# UNITED STATES PATENT AND TRADEMARK OFFICE

10/587,762

<b>Office Action Summary</b>	<b>Application No.</b> 10/587,762	<b>Applicant(s)</b> PINGEL ET AL.	
	<b>Examiner</b> MICHAEL LAPAGE	<b>Art Unit</b> 2886

### **DETAILED ACTION**

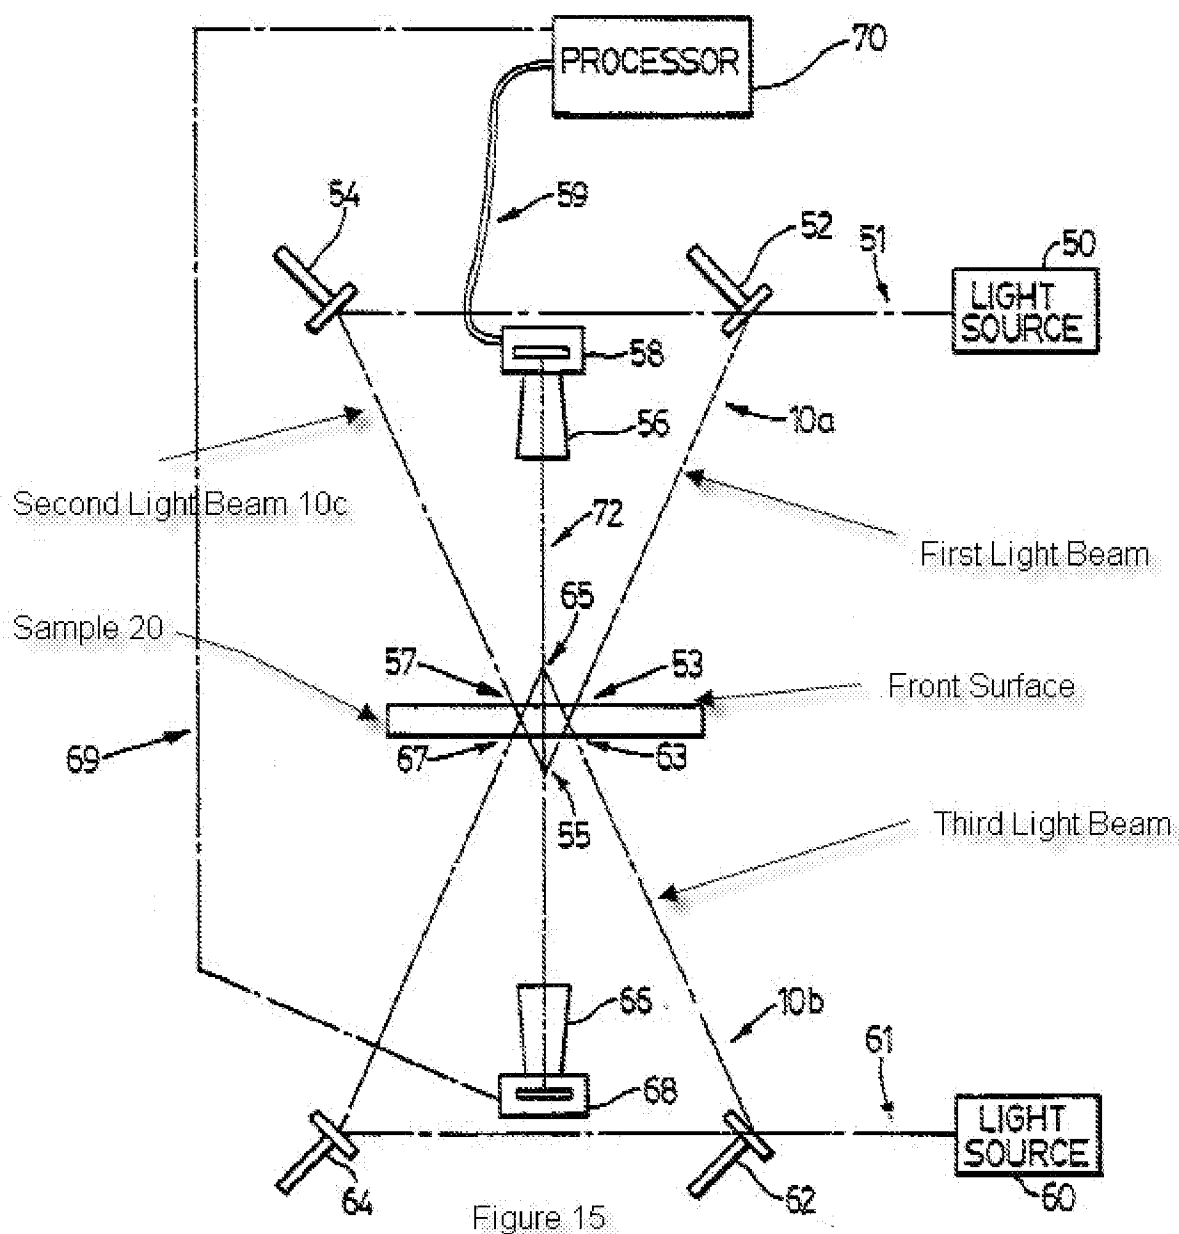
As to claim 1, Bredberg discloses and shows in figure 15 shown below, a device for measuring the thickness of a transparent sample (2), in particular a glass strip or a glass pane,

having a first light beam [L1] (10a), in particular a first laser beam, incident on the front surface (8) [i.e. Front surface labeled below in figure] of the sample (2) obliquely at a first incident angle ( $\alpha.1$ ) (col. 3, lines 32-37; where as shown in figure 15 the angle is oblique to the surface),

having a second light beam [10c] (L2), in particular a second laser beam, incident on the front surface [i.e. Front surface labeled below in figure] (8) of the sample (2) obliquely at a second incident angle ( $\alpha.2$ ) [col. 3, lines 44-52],

the first incident angle ( $\alpha.1$ ) and the second incident angle ( $\alpha.2$ ) being different (figure 15, as shown below each beam propagates toward the surface and separate angles),

and having at least one detector [58] (11, 12) for detecting the light beams (L1', L1'', L2', L2'') of the first and second incident light beams [10a, 10c] (L1, L2) reflected by the sample (2), and for determining their position [col. 8, lines 30-47; where the position of impact of the beams on the surface of sample 20 is being detected] , characterized in that

at least one incident light beam [10b] (L3) substantially parallel to the first or second light beam (L1, L2) [i.e. as shown the second and third beam are substantially parallel] is directed toward the front surface (8) of the sample (2) [col. 8, lines 23-30], and in that

at least one detector [68] (11) is provided for detecting a light beam (L3') , reflected by the sample [20] (2), of the parallel light beam (L3), and for determining its position [col. 8, lines 30-47; where the position of impact of the beams on the surface of
